Southern Nuclear Operating Company
Vogtle Electric Generating Plant Units 3 and 4 Combined License Application
Response to Request for Additional Information Letter No. 044

Enclosure: Response to NRC RAI Letter No. 044 on the VEGP Units 3 & 4 COL
Application Involving the Offsite Electrical Power System

FSAR Section 8.2, Offsite Power System

eRAI Tracking No. 4067

Figure 1
Analysis of Overhead Transmission Line Crossings

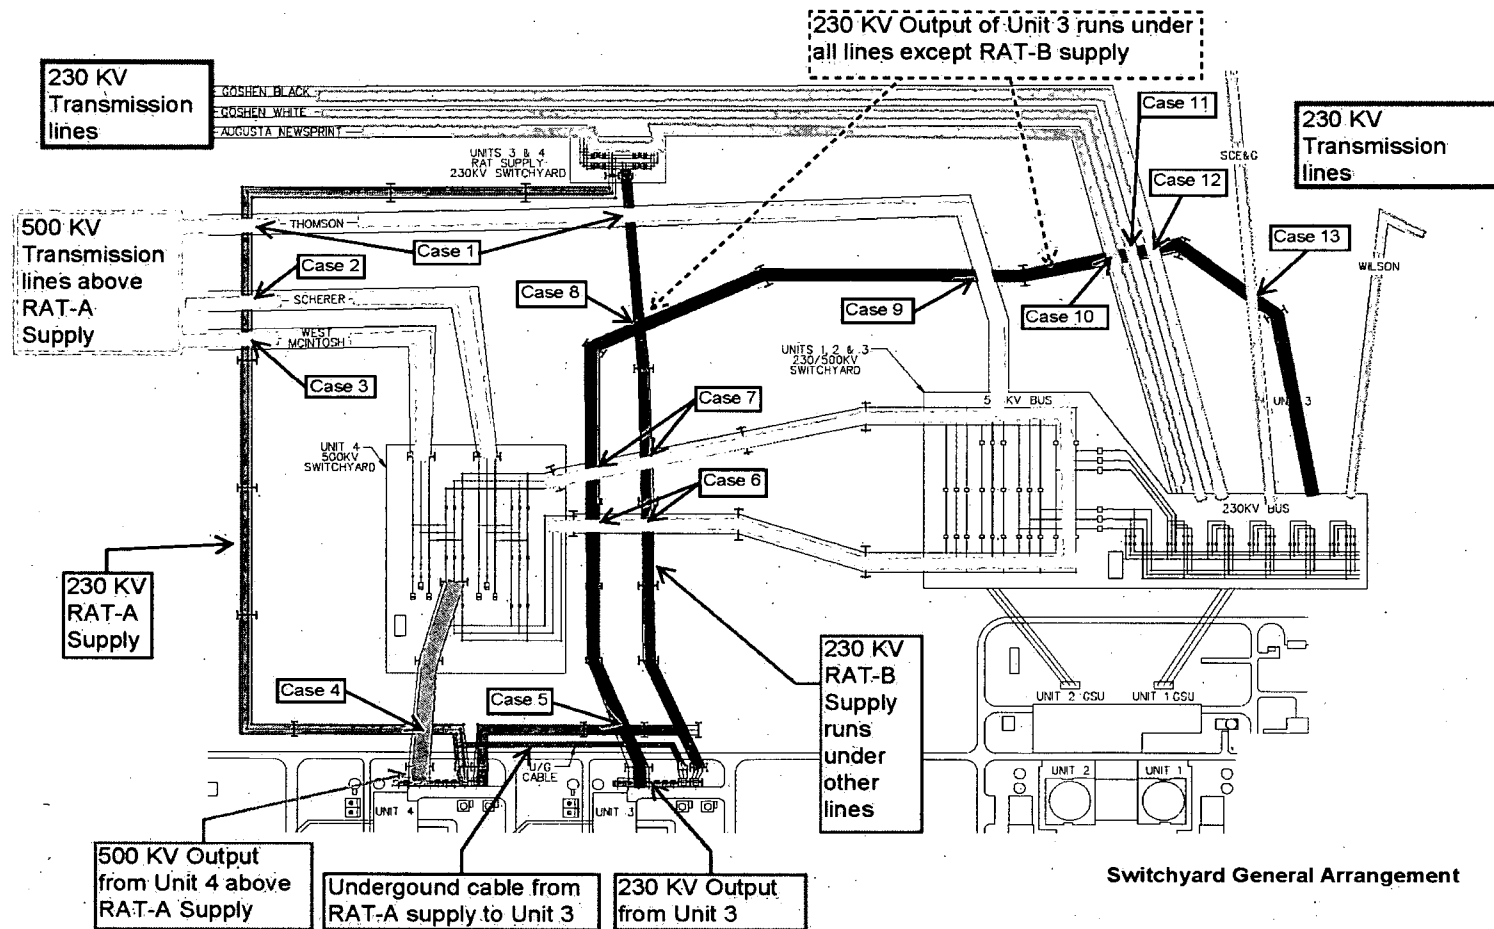
Regulatory Guide 1.206, "Combined License Applications for Nuclear Power Plants (LWR Edition)," recommends that the FSAR description of offsite power should include all unusual features of the transmission lines such as crossovers or proximity of other lines (to ensure that no single event such as a tower falling or a line breaking can affect availability of offsite power to Units 3 and 4). Figure 8.2-202 of the VEGP FSAR shows several line crossings. The NRC staff is concerned that during adverse weather conditions high winds could cause the loss of both the 500 kV and 230 kV lines to supply offsite power to Units 3 and 4. Perform an analysis of each crossing of lines and demonstrate that this vulnerability is acceptable for Vogtle offsite power system design for Units 3 and 4.

An analysis was performed of transmission line crossings within the area of the Vogtle site. Sixteen line crossing locations were evaluated to demonstrate that offsite power would be available to both Unit 3 and Unit 4 from at least one of the three available offsite power supplies to each unit and to confirm that Units 1 and 2 would not be affected. A nonmechanistic failure was assumed for each of the 16 transmission lines (a line is considered to be any one of the three phases) allowing it to fall on the line or lines immediately below it, resulting in a fault on each of the associated lines. In three cases, the falling line was assumed to contact two lines below. In all, 13 separate cases of falling transmission lines were evaluated. No single failures of protective relaying or breakers were assumed in this evaluation.

The evaluation demonstrated that, in each case, at least one offsite power supply remained available to both Unit 3 and Unit 4. In addition, there were no adverse effects to Unit 1 or Unit 2. The following attachments are provided as supporting information for this response. Figure 1 shows the layout of the Vogtle switchyards and associated transmission network along with the cases studied. The overhead line for each crossing is shown as the unbroken line. Table 1 summarizes the results of the evaluation. The information shown in the Application Revision section below will be incorporated into a future application revision.
